Subregional RTEP Committee – Western FirstEnergy Supplemental Projects

February 14, 2025

Changes to the Existing Projects

ATSI Transmission Zone M-3 Process Ellsworth Substation – s1952 Scope Change

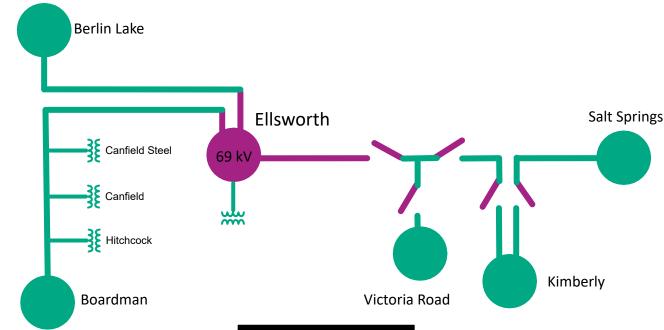
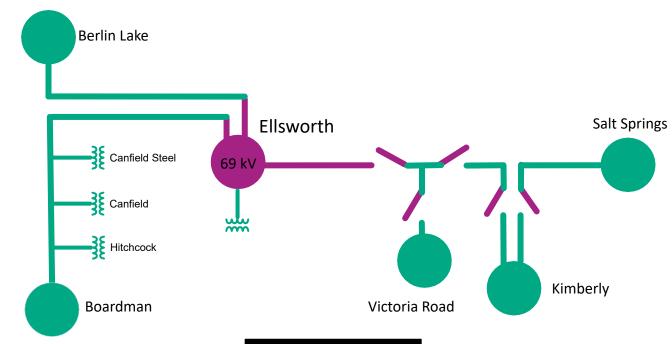
Reason for Revision (02/14/2025):

Clarify and add scope to construct the new Ellsworth – Kimberly 69 kV Line.

- At Ellsworth Substation
 - Expand and reconfigure existing Ellsworth Substation to a new 69 kV four-breaker ring bus substation
 - Install associated line relaying and control
- Loop in the existing Berlin Lake Boardman 69 kV Line into Ellsworth Substation creating two new circuits:
 - Berlin Lake Ellsworth 69 kV Line (5.1 circuit miles)
 - Boardman Ellsworth 69 kV Line (11.9 circuit miles)
- At Kimberly
 - Install two 69 kV SCADA controlled switches
- At Victoria Road
 - Install three 69 kV SCADA controlled switches
- Construct a new Ellsworth Kimberly 69 kV Line (approximately 9.7 miles)

Estimated Project Cost: \$27 M \$36.3M
